DOCUMENT 00 91 01 –

ADDENDUM NO. 02

C2.1

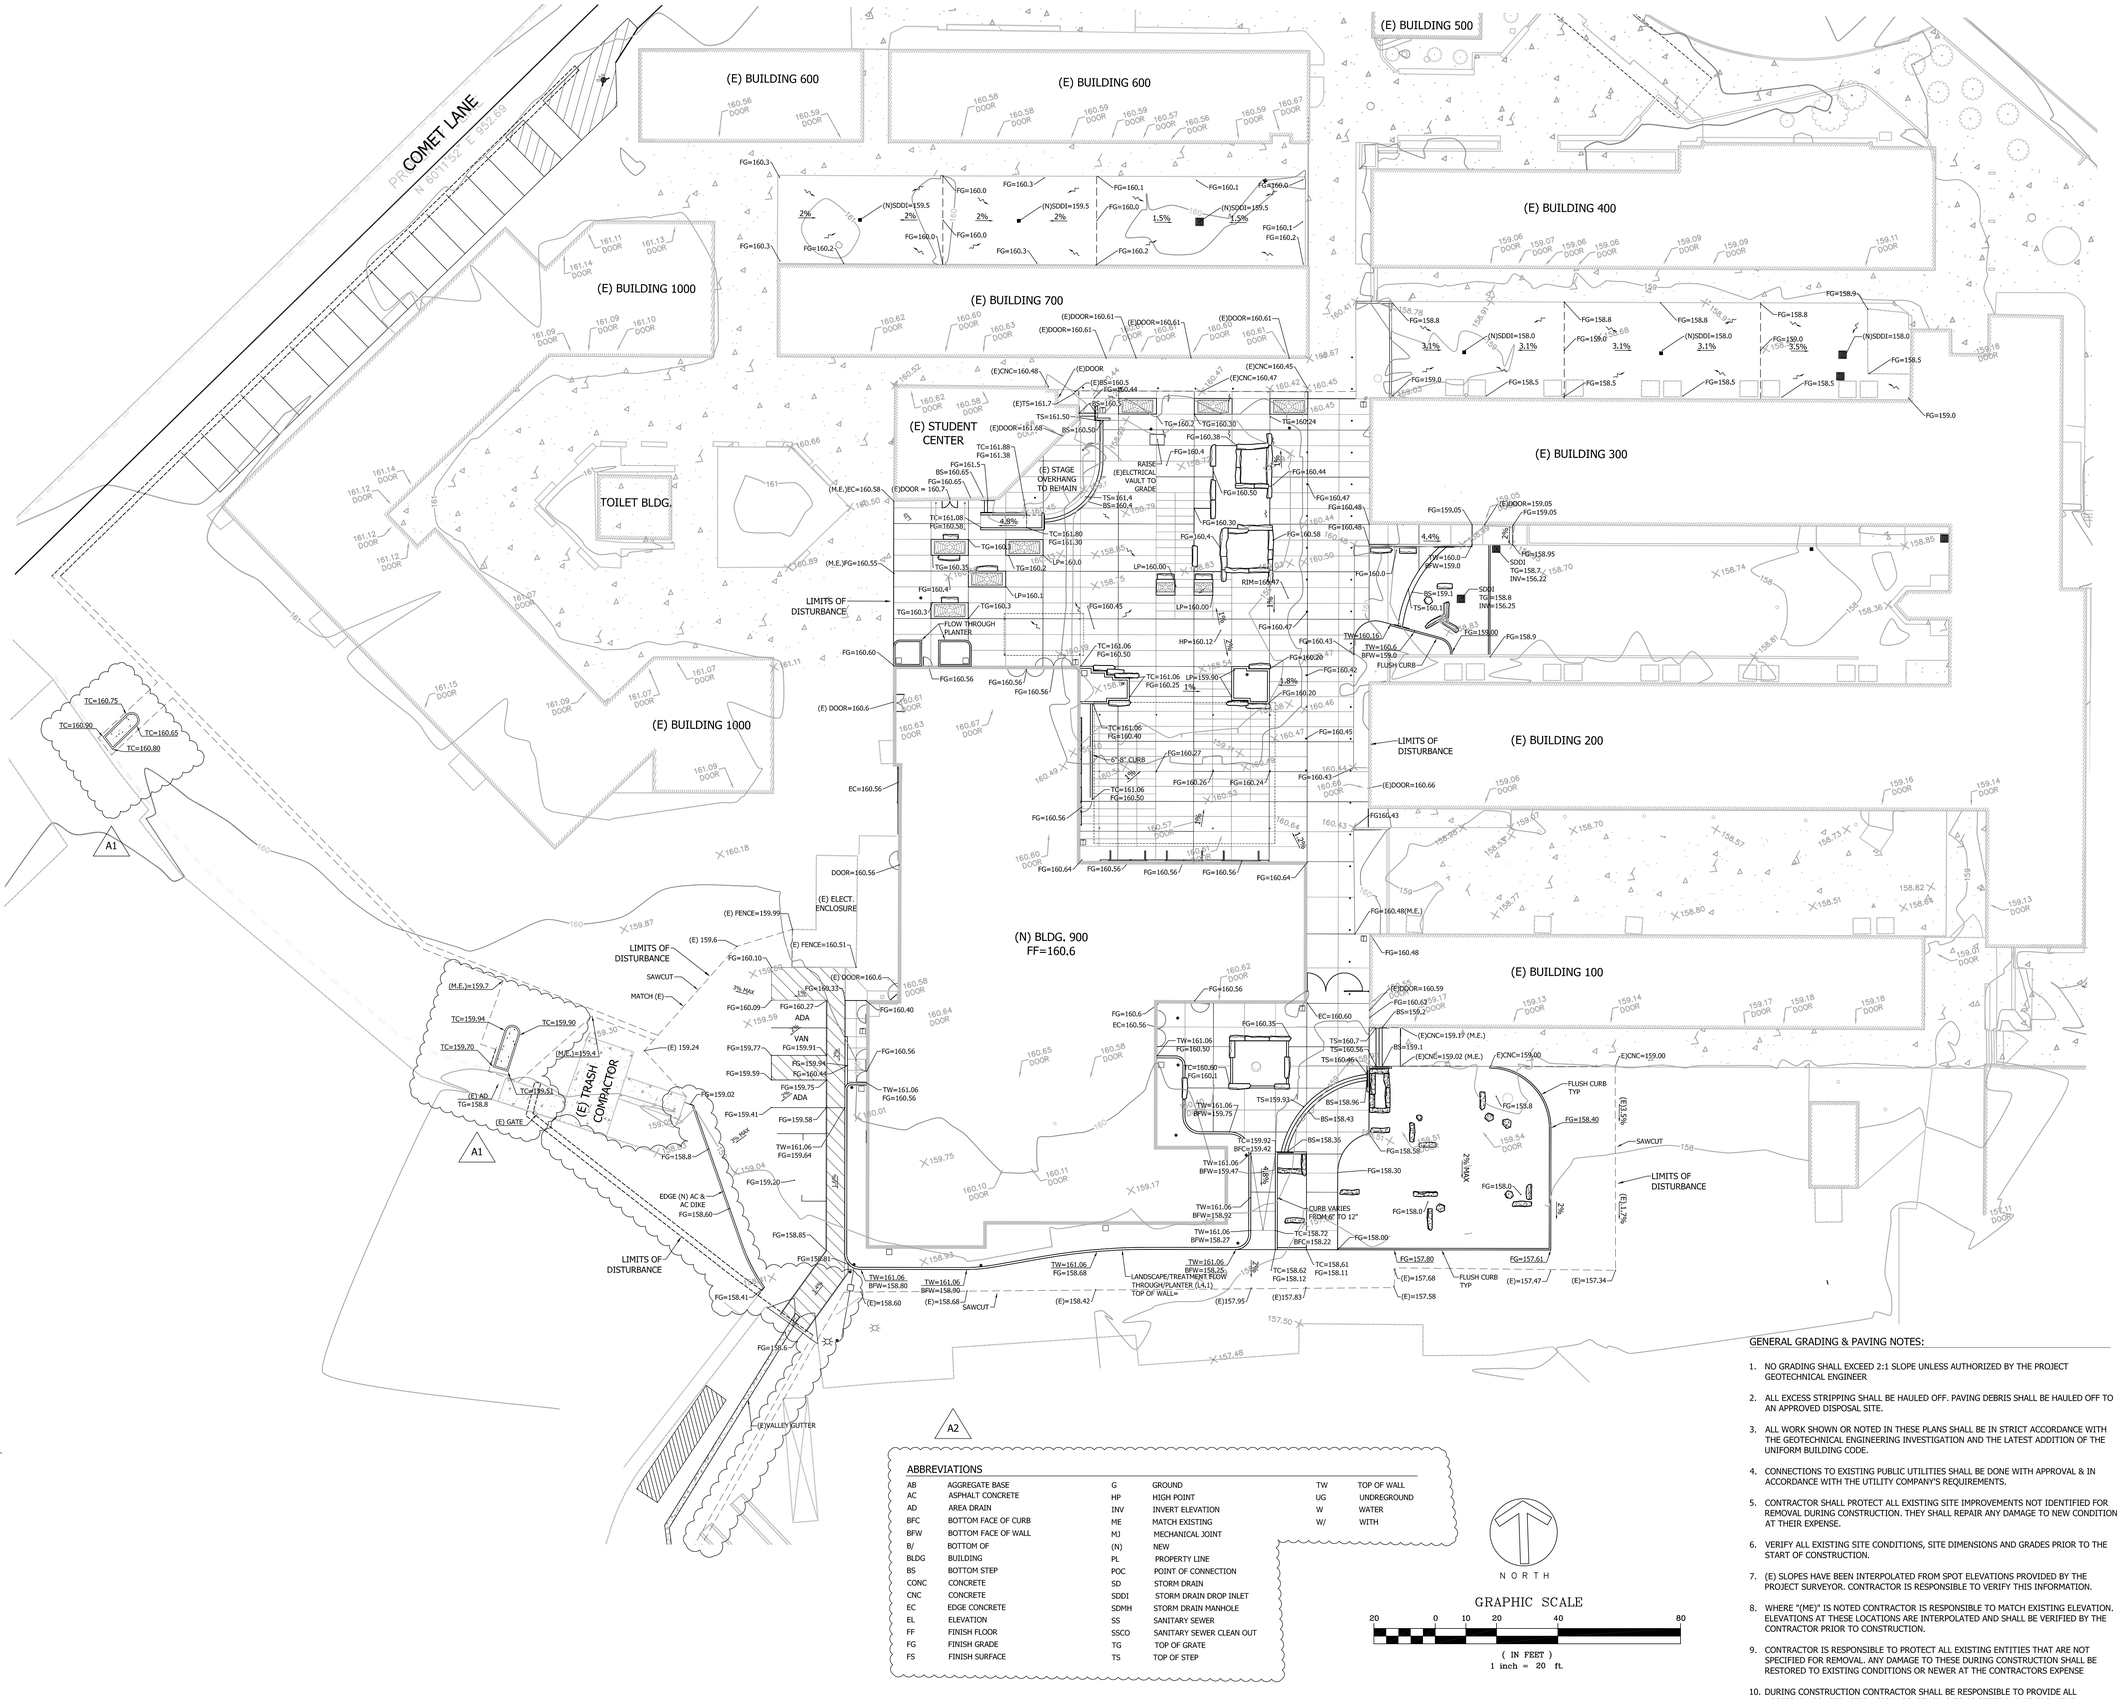
Question: Sheet C2.1 Horizontal Control & Paving Plan - In the site improvement legend there is a call-out for (N) AC (Vehicular) which references detail 1A on C7.2, where is this used? i.e. none could be found.

Answer: **C2.1: Added callouts in Addendum #1 to plan referencing new AC "vehicular." See note #15.**

C3.1

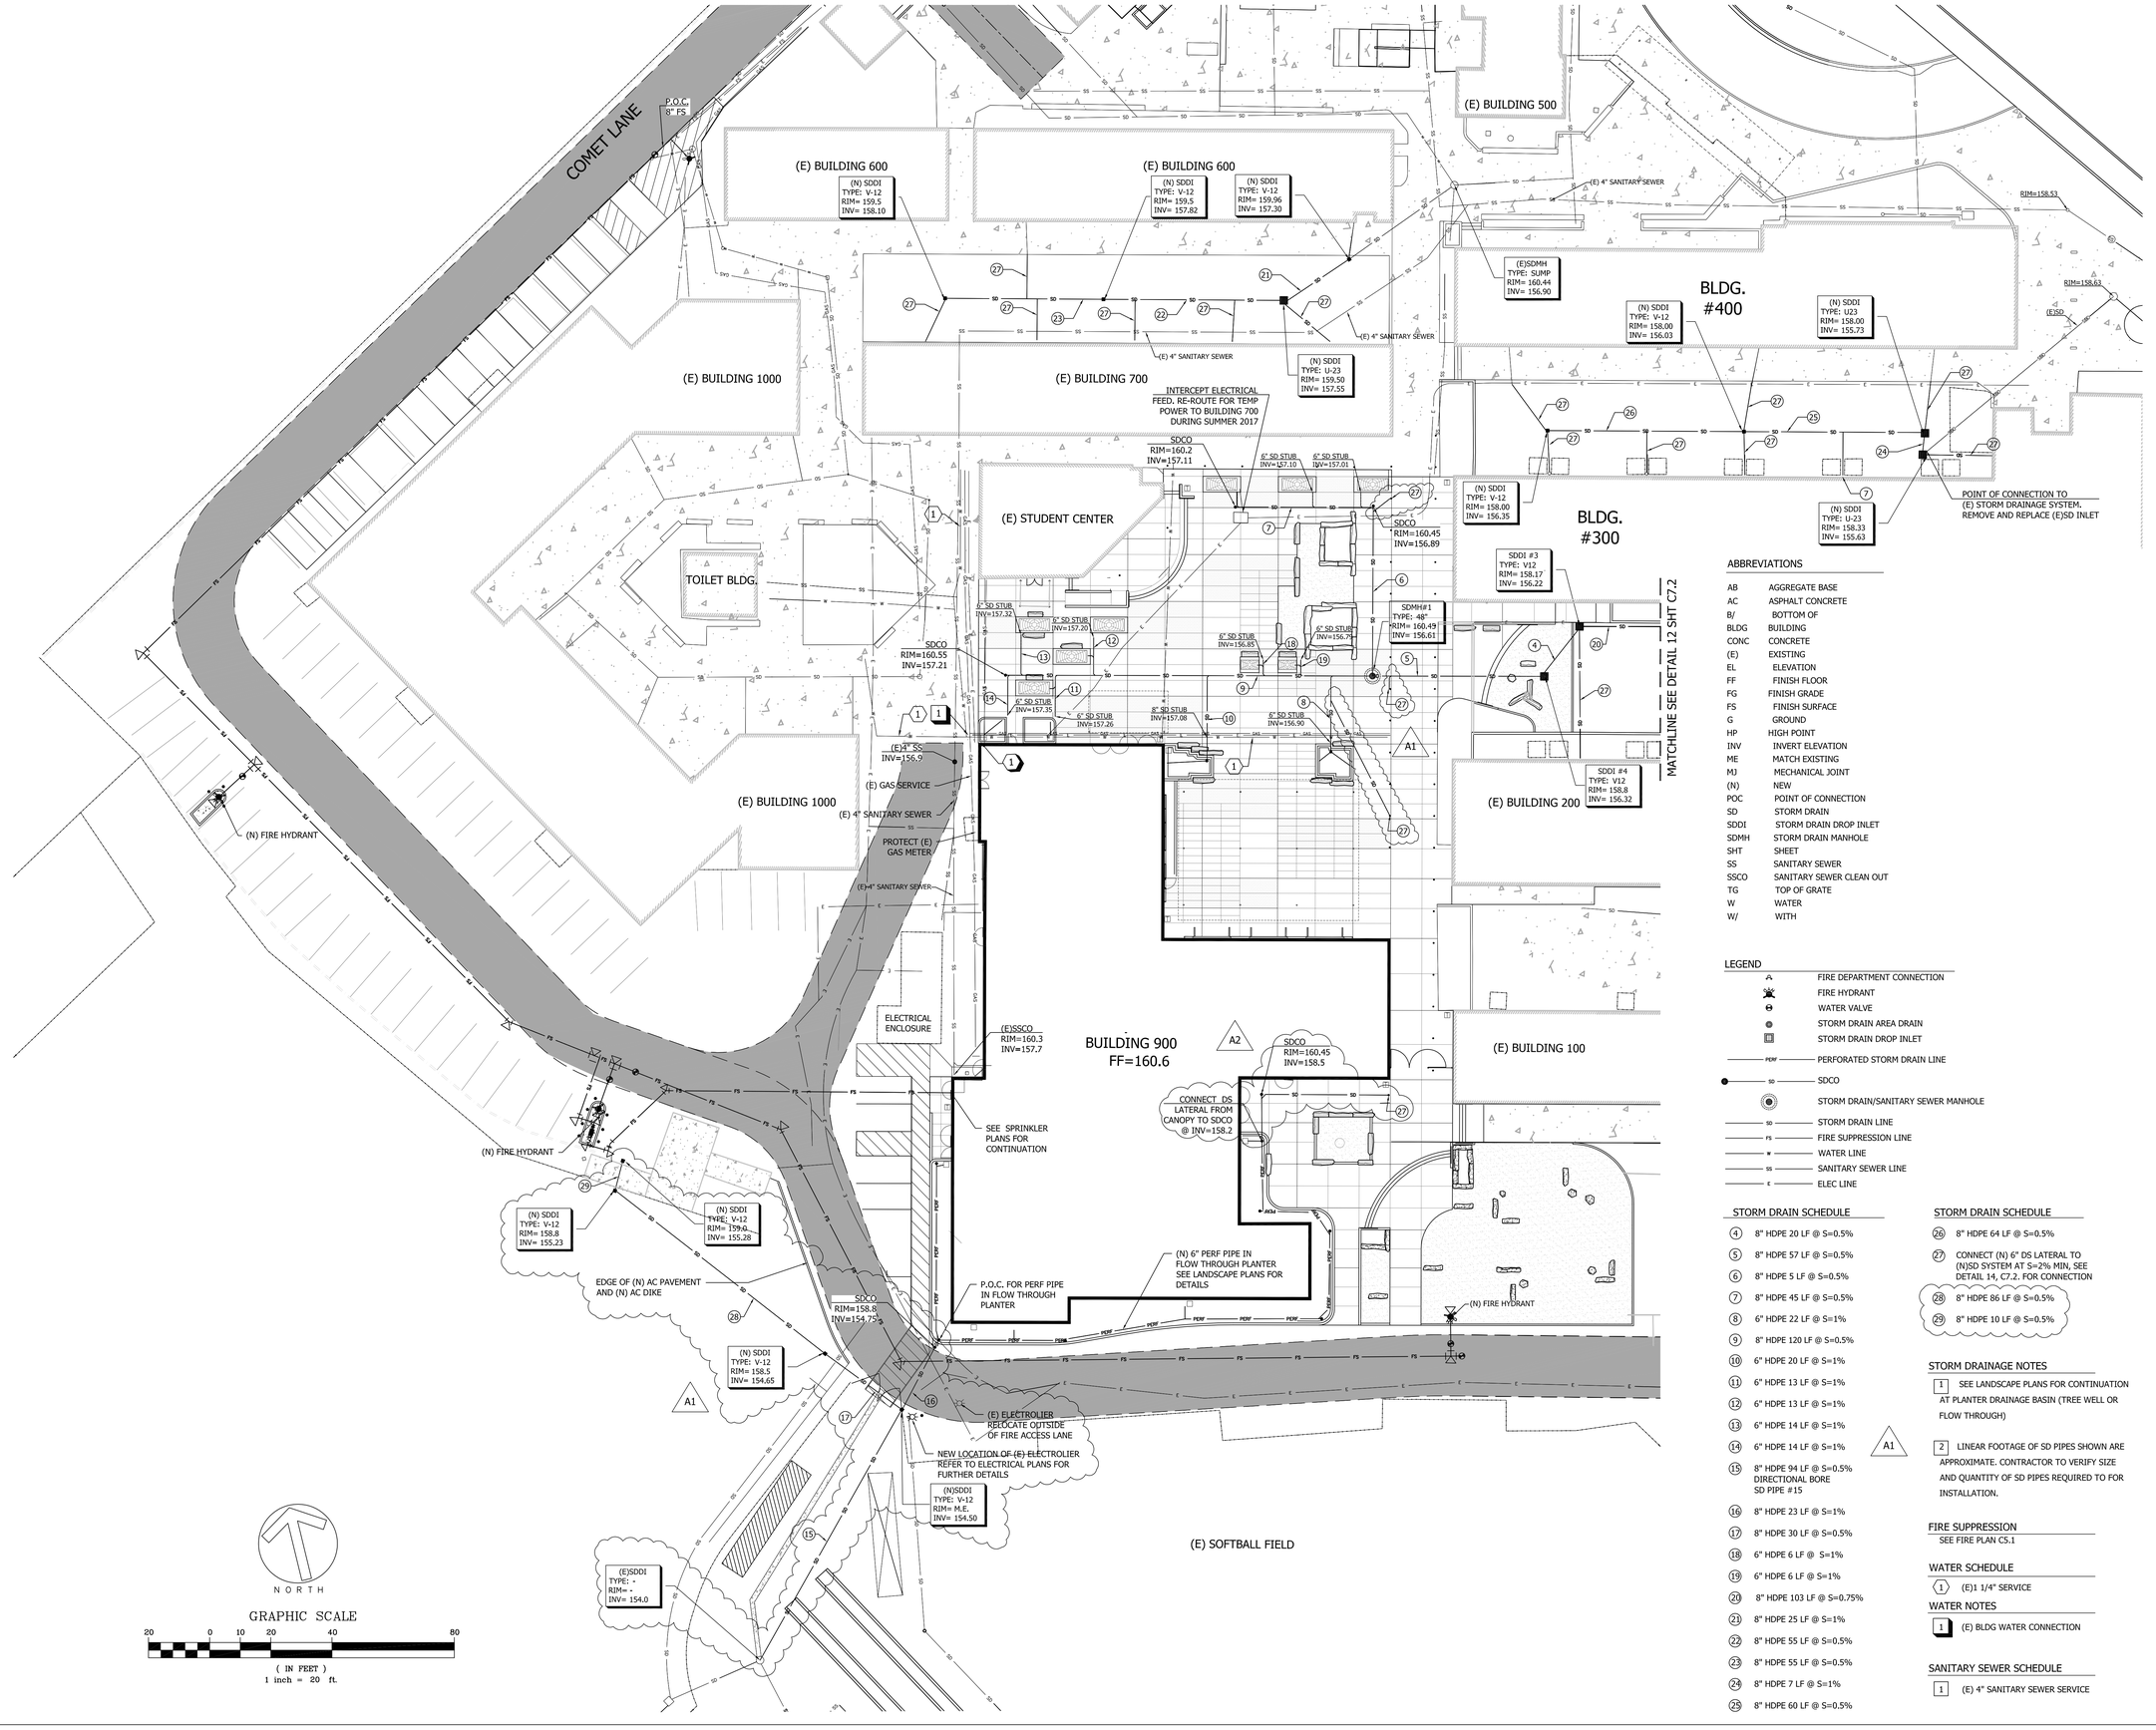
Question: Sheet C3.1 Grading Plan - At the planter on the SE – S & SW corner of the building uses abbreviations TW, BFC and BFW that are not mentioned on sheet C1.1 abbreviations. Please clarify.

Answer: **TW is Top of Wall, BFC is Bottom Face of Curb, BFW is Bottom Face of Wall. Abbreviations Legend has been added to C3.1 in Addendum #2.**

A3.00

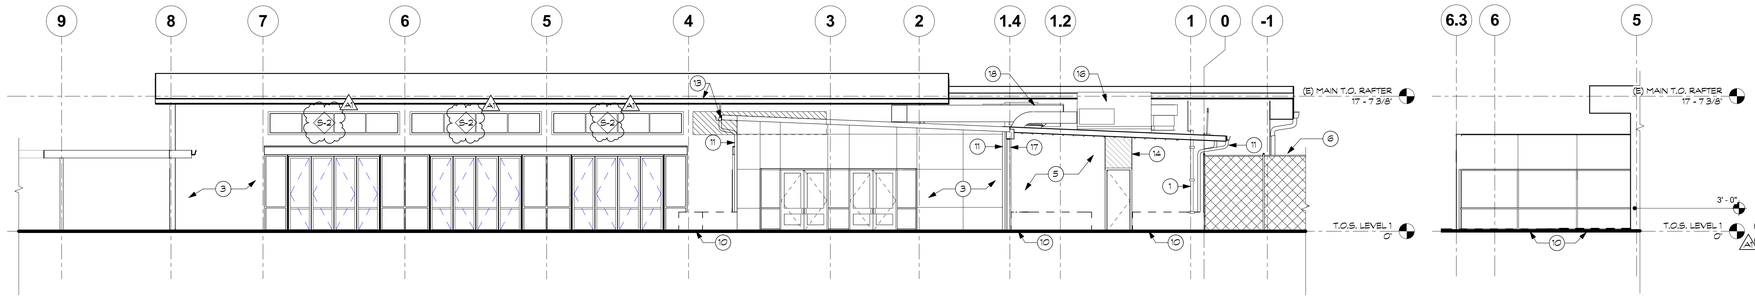
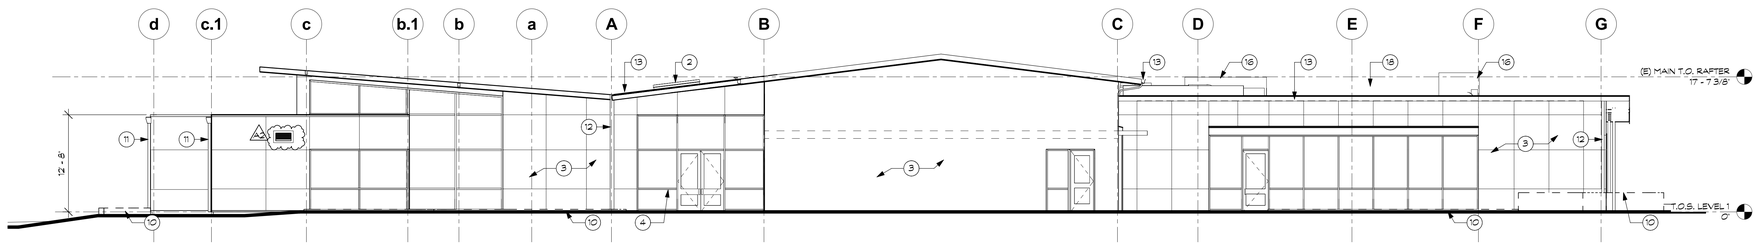
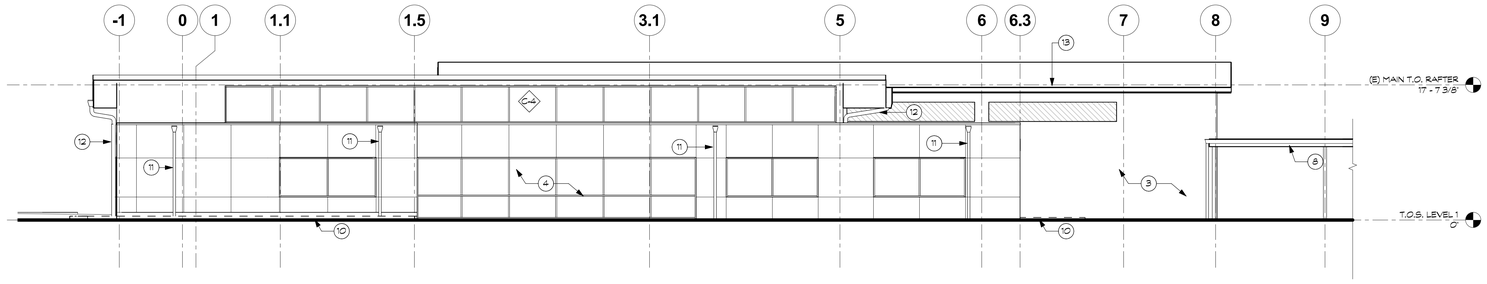
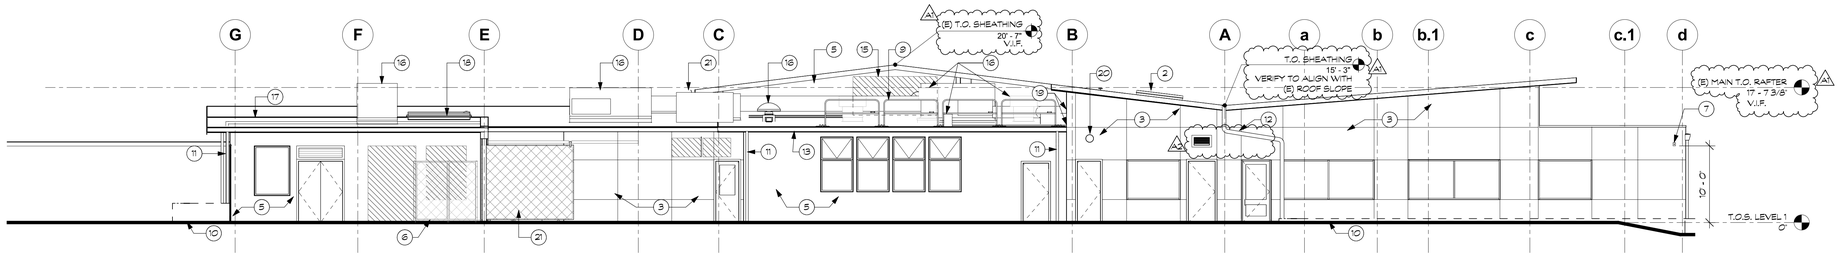
Sheet A3.00 – Exterior Elevations
A. Louver relocated to above door to Resource, view 1.
B. Louver added to east elevation per mechanical drawings, view 3.

A5.00

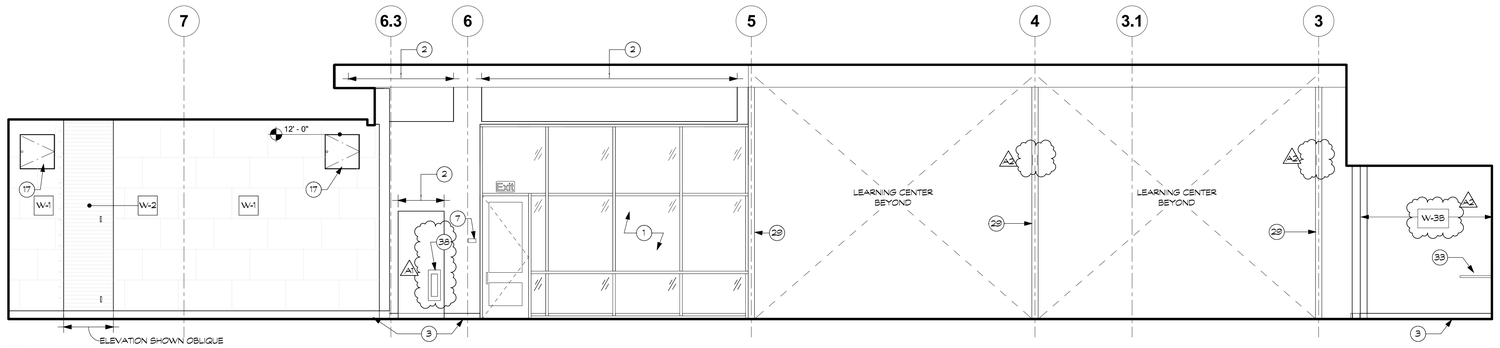
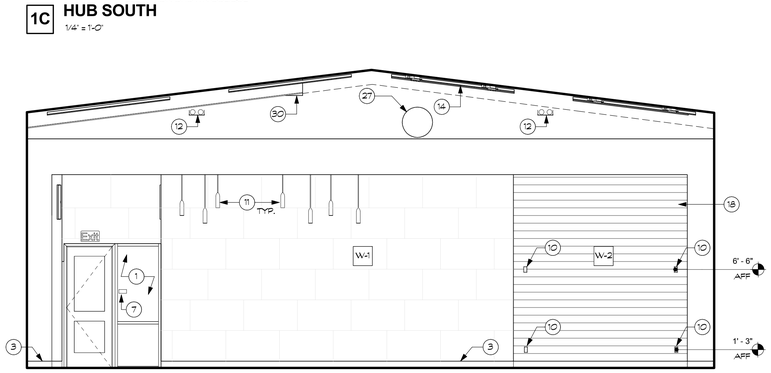
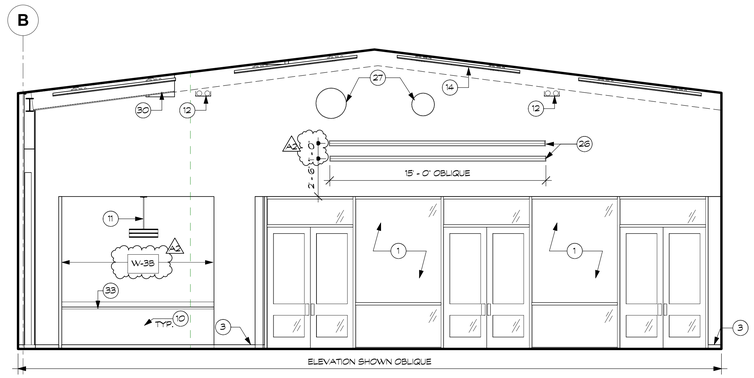
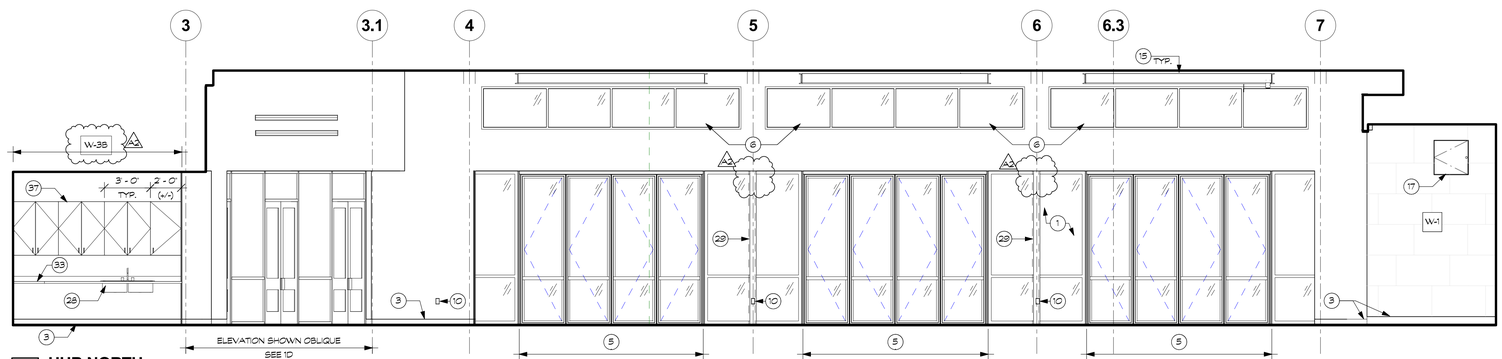
Sheet A5.00 – Interior Elevations
A. Linear return grille height changed to 1'-0" above lower grille, view 1D.
B. Column-mounted light fixtures removed.
C. W-3A and B colors clarified, typical all interior elevations. Accents in Hub shown.

17 **ACOUSTIC TREATMENT AT MECHANICAL UNIT**
1 1/2" = 1'-0"

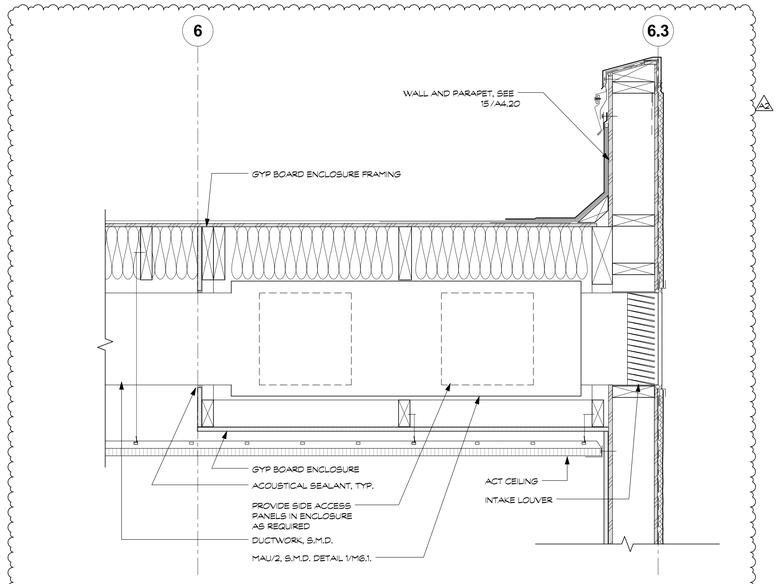
Sheet A8.01 – Section Details
A. Round column sections changed to square, typical all details (#5 this sheet).
B. Detail 17, Acoustical treatment at mechanical unit provided.
